## Mason Landing Townhomes

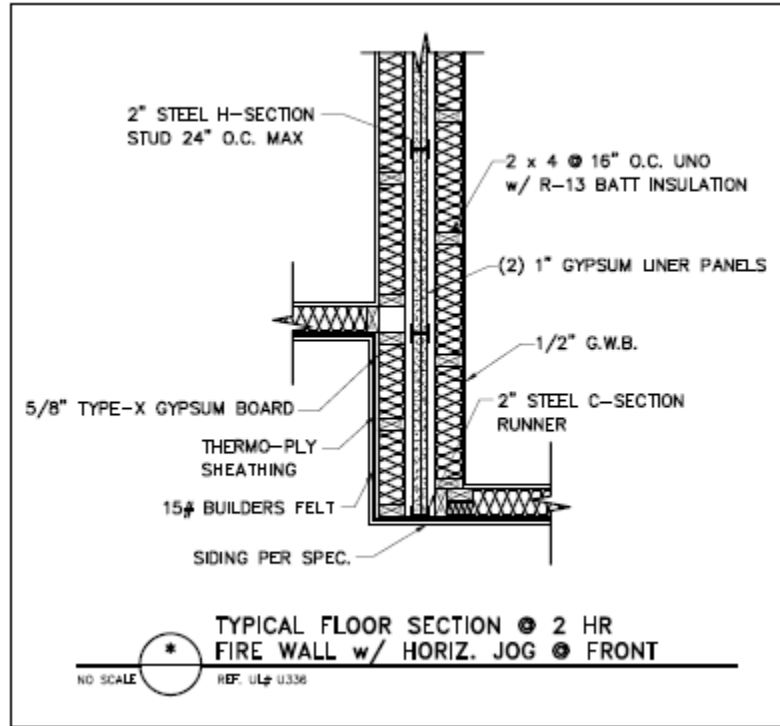
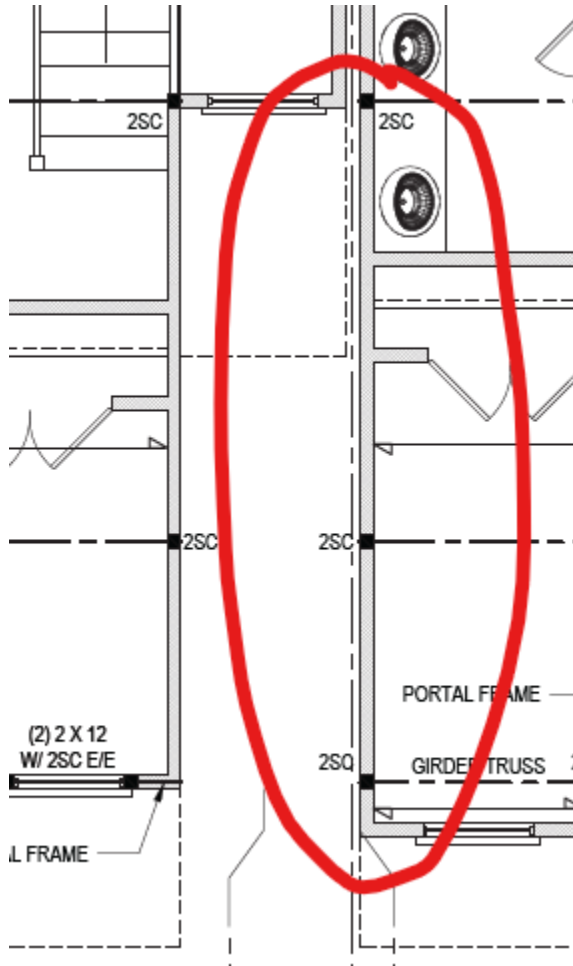
Are they just asking about the area below? The UL U336 jog detail won't apply because that part is exterior wall as they mention and it only needs to be a 1 hour wall. Do they want us to provide a detail for the 1 hour exterior fire wall?
